**From:** Cook, Pat (DEQ)  
**Sent:** Monday, October 05, 2015 8:31 AM  
**To:** Benzie, Richard (DEQ)  
**Subject:** RE: Flint schematic in OEL

**From:** Crooks, Jennifer [<mailto:crooks.jennifer@epa.gov>]  
**Sent:** Friday, October 02, 2015 12:46 PM  
**To:** Busch, Stephen (DEQ); Prysby, Mike (DEQ); Rosenthal, Adam (DEQ); Benzie, Richard (DEQ)  
**Cc:** Poy, Thomas  
**Subject:** Flint schematic in OEL

If you need a schematic for the Flint water treatment plant, there's one included in the August 2015 OEL report posted on City of Flint's website.

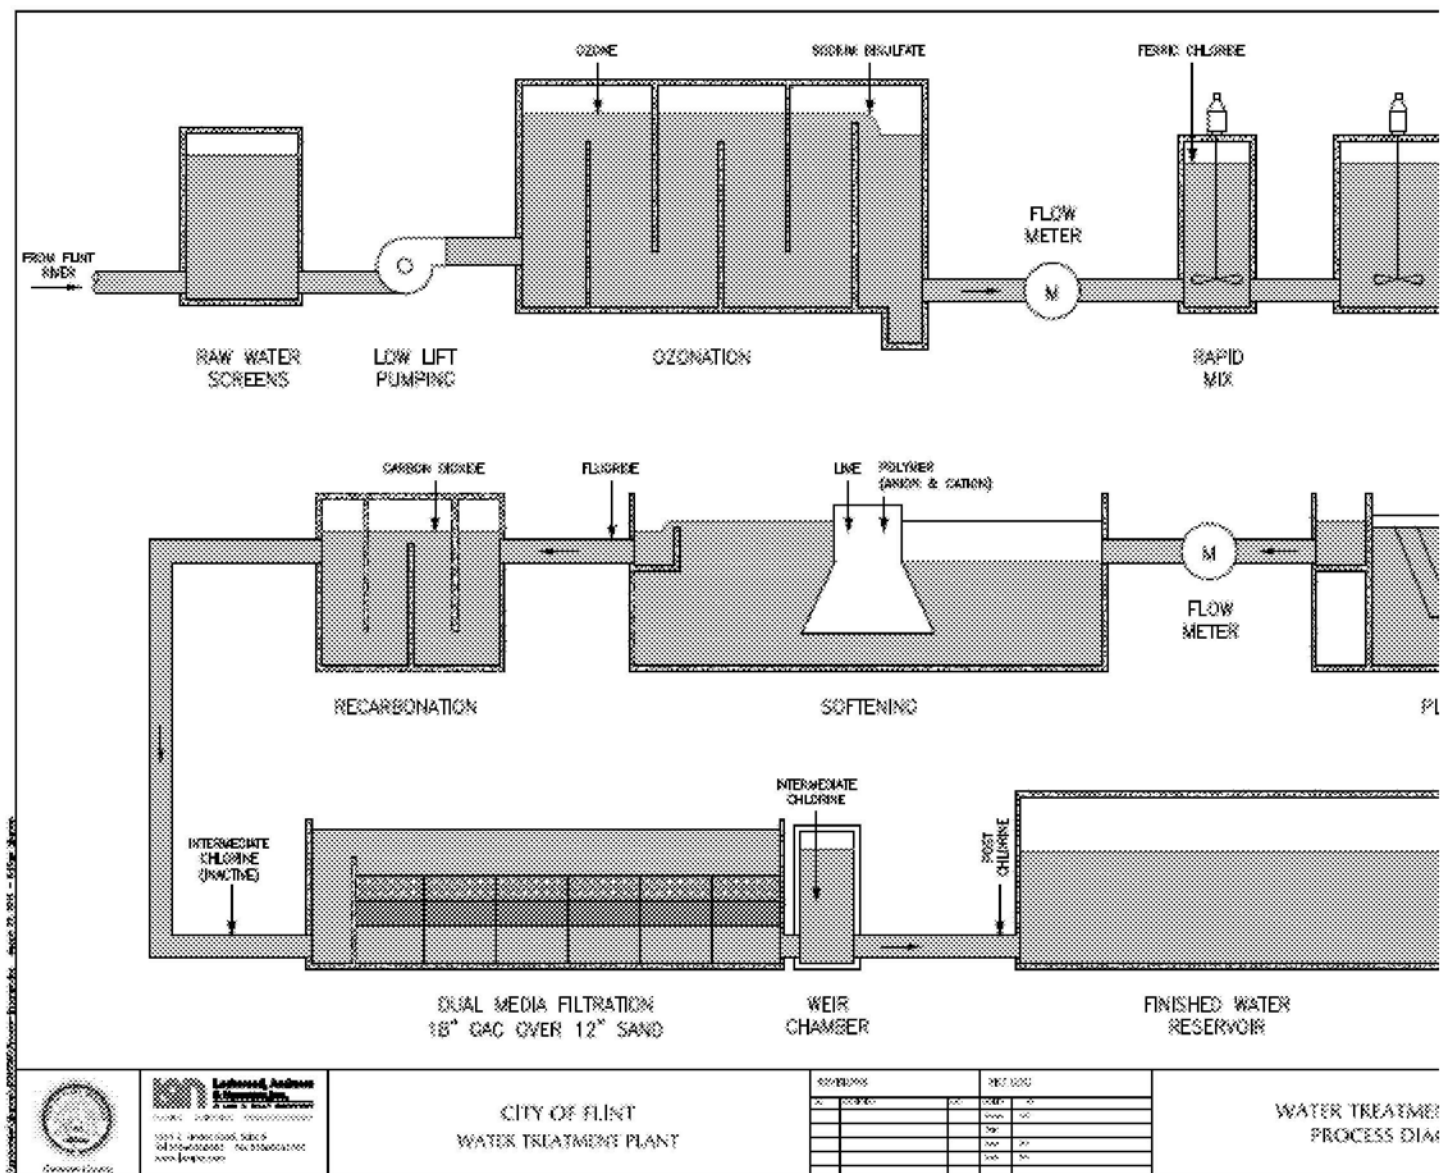
We have allowed it from time to time and in Flint's situation I believe it was allowed based on a quick and dirty pilot study.

Have we routinely allowed filter plants to have only 12-inches of sand in there dual-media filters?
